Access Compliance Report

Public Rights-of-Way

Intersection ID: 47663	Main Street: ELM_BEND_DR	Cross Street: COMISKEY_LN	Location: NE
ADA ID: 08CE75618DEA	Ramp Type: BlendTrans1	Initial Pass/Fail: Fail	Overall Compliance: No
		Severity Score: 10

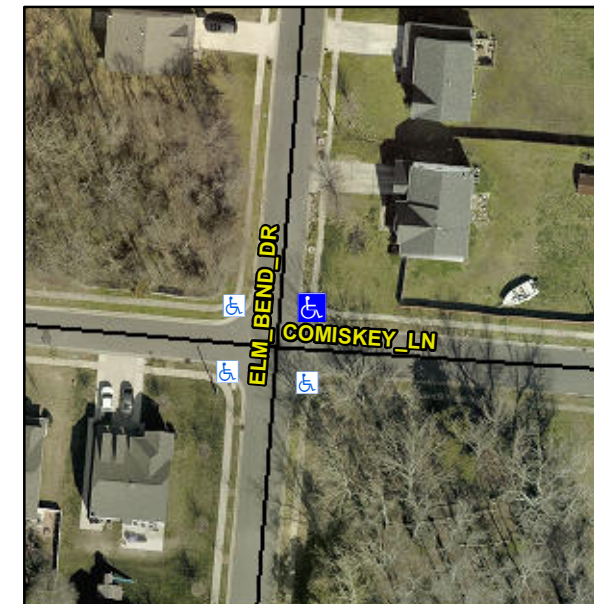
CURB LIP 2.0

R304.5.1, R304.5.3

Compliance	Description	Data	Compliance	Description	Data
N/A	Ramp Length (in)	48.0	Yes	BlendTrans Slope (%)	3.7
No	Ramp Width (in)	46.0	No	BlendTrans XSlope (%)	3.4
N/A	Flare Type LT	N/A	N/A	Flare Type RT	N/A
N/A	Flare Slope LT (%)	N/A	N/A	Flare Slope RT (%)	N/A
N/A	Flare Traversable LT?	N/A	N/A	Flare Traversable RT?	N/A
N/A	Landing Length (in)	N/A	N/A	DWS Provided?	N/A
N/A	Landing Width (in)	N/A	N/A	DWS Contrast?	N/A
N/A	Landing Slope (%)	N/A	N/A	DWS Length (in)	N/A
N/A	Landing X Slope (%)	N/A	N/A	DWS Full Width?	N/A
N/A	Landing Curb? (Y/N)	N/A	N/A	DWS Offset (in)	N/A
N/A	Shared Landing?	N/A			
N/A	Gutter Ponding?	N/A	N/A	Gutter Slope (%)	N/A
N/A	Gutter Lip Ht (in)	N/A	N/A	Gutter X Slope (%)	N/A
N/A	Painted X Walk1?	No	N/A	Painted X Walk2?	No
	X Walk 1 Direction	To W		X Walk 2 Direction	To S
	X Walk 1 Width (in)	N/A		X Walk 2 Width (in)	N/A
	X Walk 1 Slope (%)	1.4		X Walk 2 Slope (%)	2.4
	X Walk 1 X Slope (%)	0.2		X Walk 2 X Slope (%)	0.8

Remove & Replace Curb Ramp With Two New Directional Ramps or Equivalent.
